SITE: Land at Tree Cottages, Credenhill, Herefordshire, HR4 7ES
TYPE: Planning Permission
DESCRIPTION: Erection of two bungalows and garages. Construction of new vehicular access and associated works.
APPLICATION NO: 132278
GRID REFERENCE: OS 344716, 243057
APPLICANT: Ms J Richards
AGENT: Mr Linden Alcock, Alcock Surveyors
DATE OF THIS RESPONSE: 25/05/2016

This response is in regard to flood risk and land drainage aspects, with information obtained from the following sources:

Figure 1: Environment Agency Flood Map for Planning (Rivers and Sea), May 2016

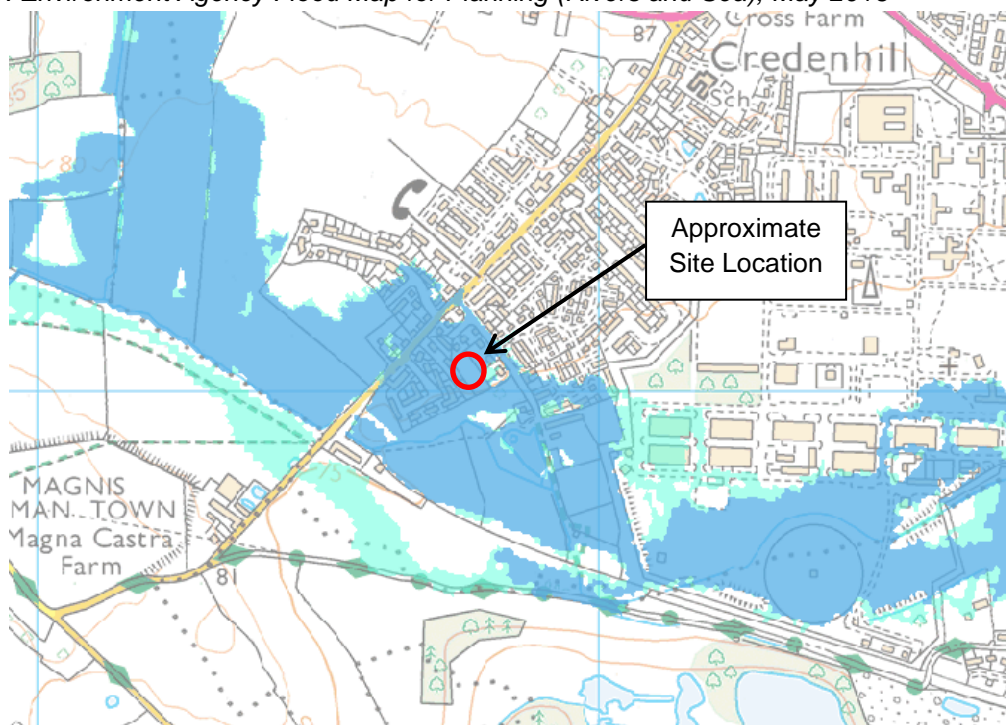
Review of the Environment Agency's Flood Map for Planning (Figure 1) indicates that the site is located within the high risk Flood Zone 3. Flood Zone 3 comprises land where the annual probability of flooding from fluvial sources is greater than 1% (1 in 100). The source of this flood risk is fluvial (river) flooding.

The Applicant has submitted an FRA which acknowledges that the site is located in Flood Zone 3.

The FRA states that the site 'has never flooded in living memory, nor has any history of flooding been discovered by diligent local enquiry'. The FRA goes on to state that 'the site is surrounded by extensive modern development, none of which dwellings have flooded and most of which are at a lower level than the lowest point of the subject site'. Although relevant, these statements do not adequately clarify the current and future fluvial flood risk to the site.

Within their FRA the Applicant clarify the extent and depth of fluvial flood risk within the site boundary and consider the potential effects of climate change. For this location on the Yazor Brook, modelled flood data is held by Herefordshire County Council and can be provided to the Applicant on request. This data includes an allowance for climate change and incorporates the benefits provided by the Yazor Brook Flood Alleviation Scheme (which is discussed by the Applicant in their FRA). There is a charge for this data.

When interpreting the data held by the Council, the Applicant should note that there is an informal flood defence (earth bund) on the northern bank of the Yazor Brook which is represented in the flood model. The Applicant should give consideration to the potential flood risk to the proposed development should this earth bund fail or be removed in the future.
